**Re: Peer Review  
Old South Road Mixed-Use Development  
Nantucket, Massachusetts**

On behalf of the Nantucket Planning Board, Tetra Tech (TT) has completed a peer review of the August 26, 2016 *Traffic Impact and Access Study* prepared by Ron Muller & Associates for the proposed project located on the south side of Old South Road between Lovers Lane and Daffodil Lane. We have also reviewed the following supplemental documents received on September 19, 2016.

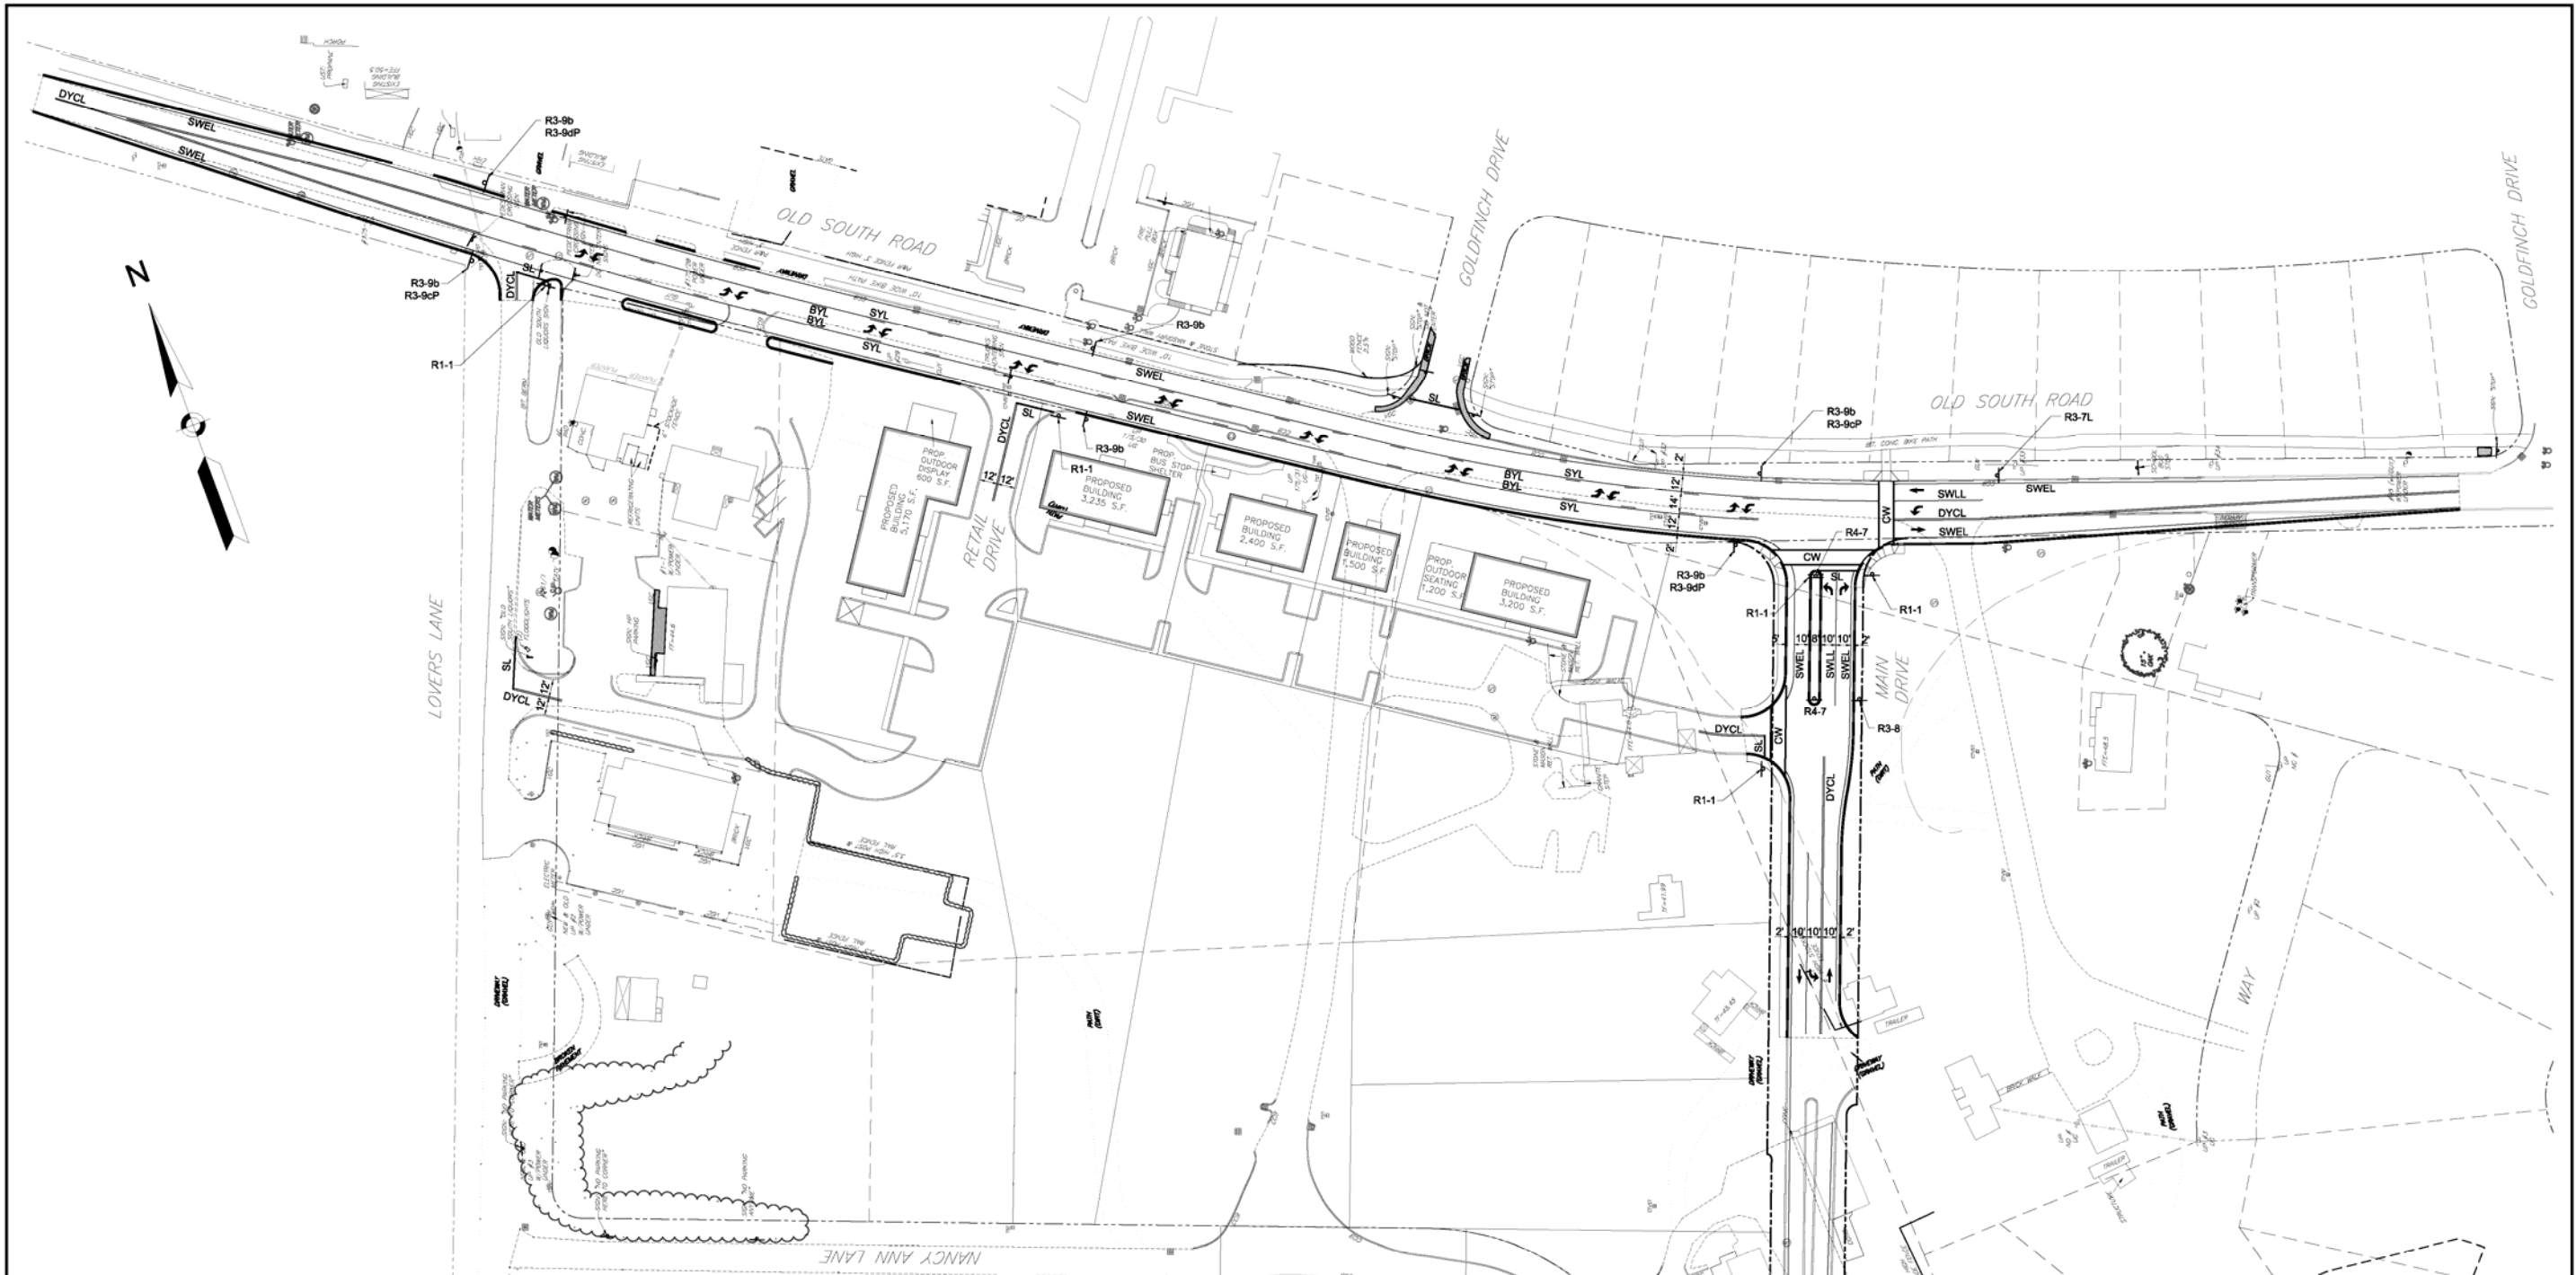
The applicant has offered to fully fund the design and construction of modifications to Old South Road along with providing additional right of way as needed. The currently proposed modifications include 14 feet of widening, required to provide a 12-foot wide through lane and a 2-foot shoulder in each travel direction with a 14-foot wide shared two-way left turn lane between Lovers Lane and Main Site Drive. The applicant's concept for Old South Road is attached for the reader's convenience. The study indicates that the purpose of the two-way left turn lane is to facilitate a left turn from side streets and driveways onto Old South Road. Motorists would have an opportunity to stack in the two-way left turn lane completing the left turn in two steps. The study indicates that the two-way left turn lane would significantly improve operations for the minor street approaches.

However, it is noted that there are no two-way left turn lanes currently located on Nantucket, two-way left turn lanes are not in character with other roadways on the island and two-way left turn lanes are not desirable to the Town.

Based on input from the Town, it is strongly suggested that the applicant consider an alternative design for Old South Road, one that makes safe pedestrian and bicycle connections to the Old South Road Bike Path a priority, enhances aesthetics of the corridor and encourages driveway consolidation wherever possible. Also, opportunities to provide traditional left turn lanes with center median islands rather than a shared two-way left turn lane are encouraged. Landscaped median islands along Old South Road are suggested and should be considered in subsequent submittals. MassDOT, in its *Project Development*

For example, with a median island on the eastbound approach to Main Site Drive, the proposed Old South Road crosswalk could be shifted from the east leg of the intersection to the west leg of the intersection, requiring pedestrians to cross only two travel lanes with the added benefit of a refuge in the median island.
